Subject: BODY VIBRATION WHEN ENGINE IDLING IN (D)RIVE AND (R)EVERSE	Bulletin No.: 01-017/19
	Last Issued: 11/14/2019

1	No.3 engine mount
2	No.4 engine mount

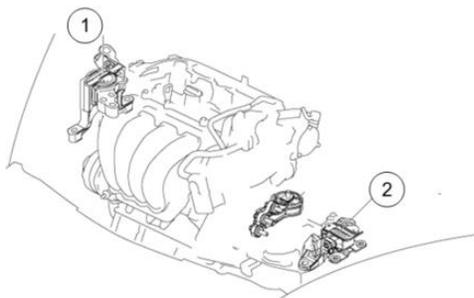
This vibration is caused by:

1.5L	The No.3 and No.4 engine mount rubber hardening during vehicle usage at high ambient temperatures which decreases the damping force.
2.0L	Components of the No.3 engine mount rubber melting inside the mount at high ambient temperatures which creates deposits on the engine mount plate that restrict engine mount plate movement.

Mass production change has not been determined at this time, but modified No.3 and No.4 engine mounts have been newly established as service parts. Their material and spring characteristic have been changed. Customers having this concern should have their vehicle repaired using the following repair procedure.

Mazda3 (1.5L)	Replace both No.3 and No.4 engine mounts with modified ones according to the instructions on MGSS (ENGINE MOUNT DISASSEMBLY/ASSEMBLY [SKYACTIV-G 1.5]).
Mazda3 and CX-5 (2.0L)	Replace the No.3 engine mount with a modified one according to the instructions on MGSS (MOUNT DISASSEMBLY/ASSEMBLY [SKYACTIV-G 2.0, SKYACTIV-G 2.5]).
